ADDENDUM: TENDER B/SM 25/27: THE CONSTRUCTION OF POLKADRAAI WATER SUPPLY SCHEME: PHASE 2

NB1 MINUTES OF TENDER CLARIFICATION MEETING

TENDER NO. B/SM 25/27
THE CONSTRUCTION OF POLKADRAAI WATER SUPPLY SCHEME PHASE 2

POLKADRAAI 355/315mm DIA PRESSURE REDUCING VALVE CHAMBER DETAIL

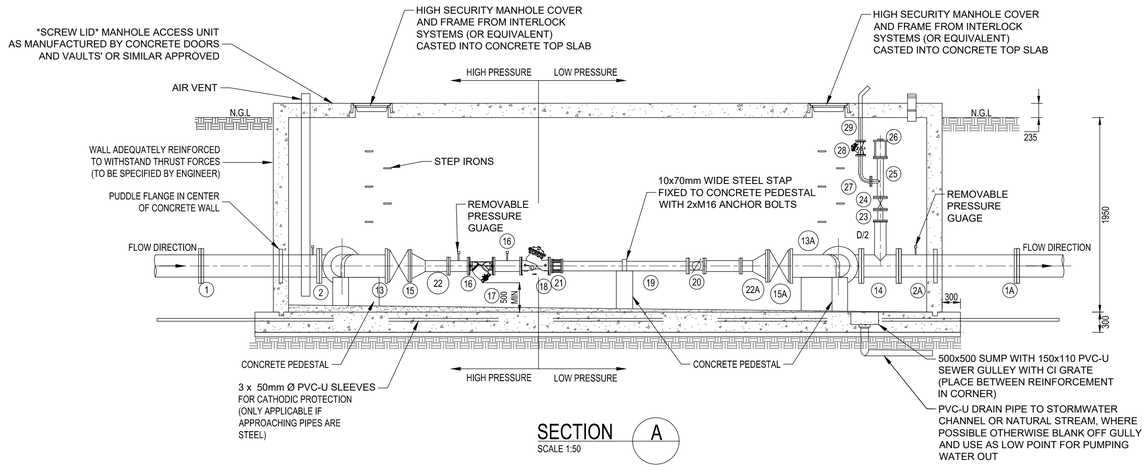
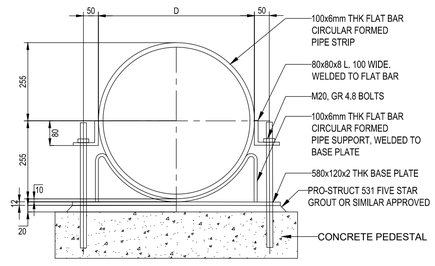
Q4. The PRV chamber drawing does not have dimensions to price it on. Can dimensions be added or quantified items be updated in the schedule of quantities?

A4.
Drawing will be updated. Drawing no. *33803.01-143-02 RevT1* will be updated and shared with all tenderers on the shared Dropbox folder under drawings.

DATE	INITIAL	No./CODE	REVISION DESCRIPTION
25/09/2026	L.M	T0/D	ISSUED FOR REVIEW
02/11/2026	L.M	T1/D	DETAIL REVISED
